**MOORE PUBLIC SCHOOLS -
SOUTHGATE ELEMENTARY SCHOOL
KITCHEN UPGRADES AND ADDITION**
Moore Public Schools - Moore, Oklahoma
AGP - Moore, Oklahoma

ADDENDUM NO. 2

August 19, 2026

FLOOR PLAN

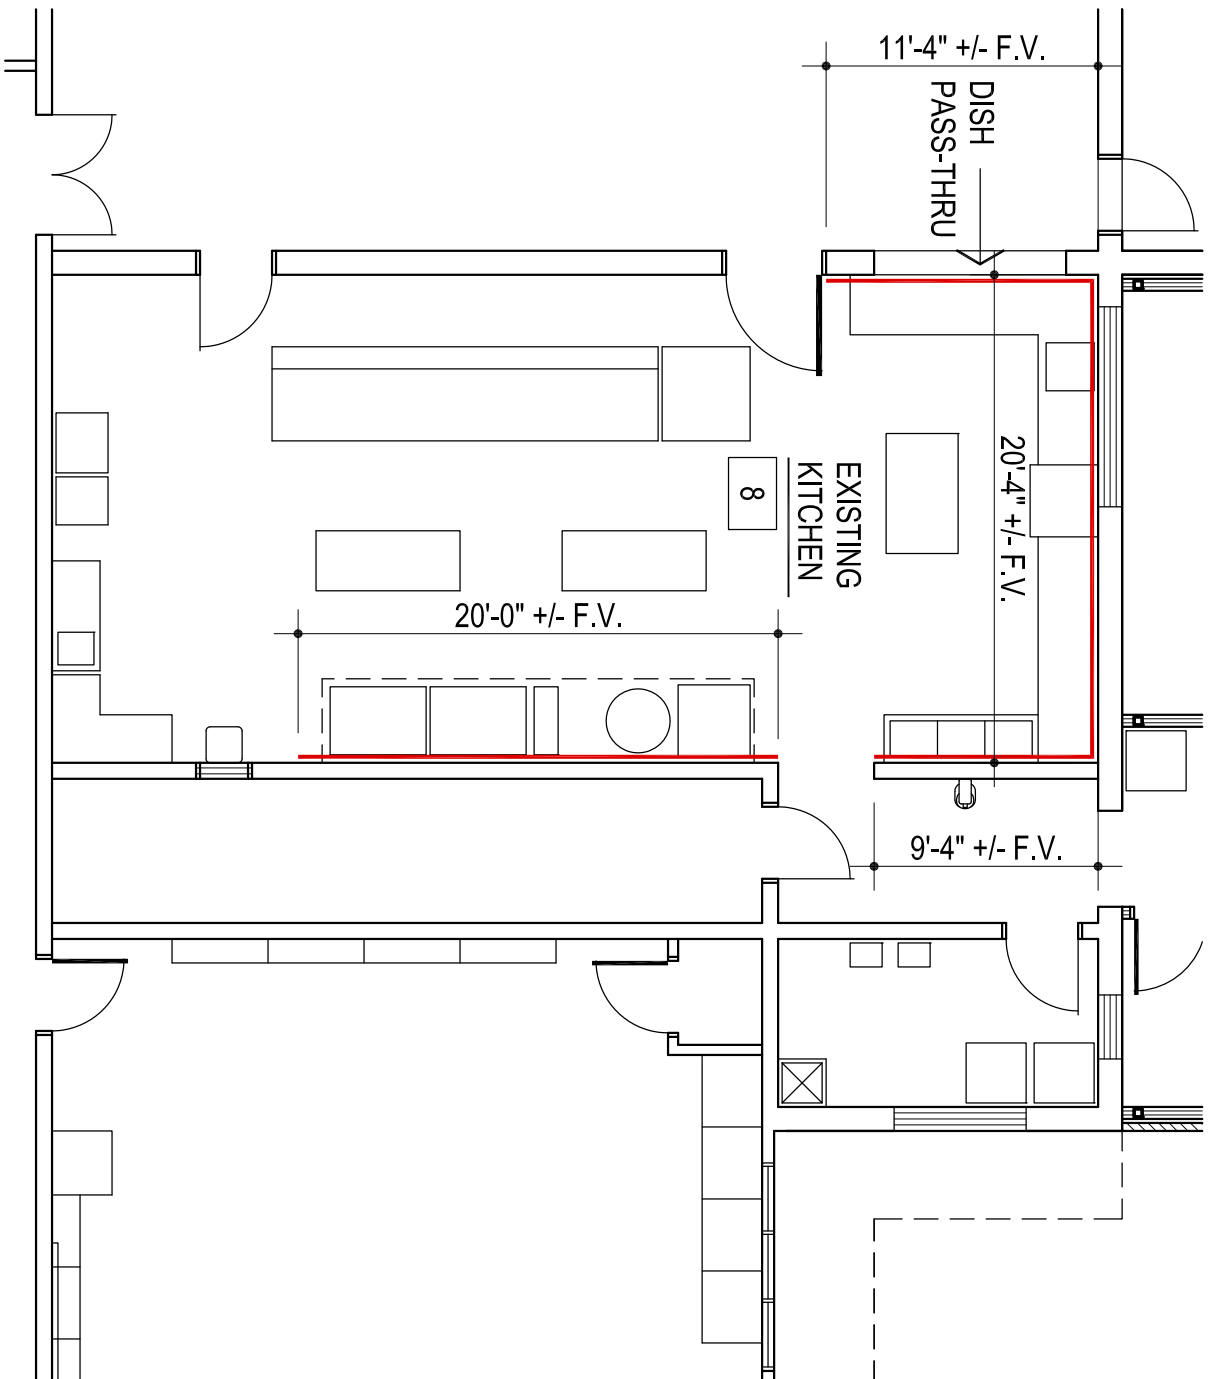
1. Sheet A101, Detail #1, Floor Plan / Sheet A102, Reflected Ceiling Plan / Sheet FS100, Detail #1, Kitchen Equipment Plan / applicable MEP Sheets: please note, the overhead kitchen hood – Kitchen Equipment Item #17 – has been included in Bid Package No. 13. Coordinate with Construction Manager.
2. Sheet A601, Detail #1, Room Finish Schedule: at Rooms #1 - Corridor, #4 – Dry Storage, & #7 – Existing Corridor, omit providing stainless steel wall panels and provide epoxy paint color #2.
3. Sheet A601, Detail #1, Room Finish Schedule: at Room #8 – Existing Kitchen, omit providing stainless steel wall panels at the entire room. Provide stainless steel wall panels at the dishwashing area three (3) walls to receive the new counters and at the cooking area behind the cooking equipment below the new overhead hood. All other walls are to receive epoxy paint color #2. Refer to attached drawing.

INDICATES WALL TO RECEIVE
NEW STAINLESS STEEL WALL PANEL
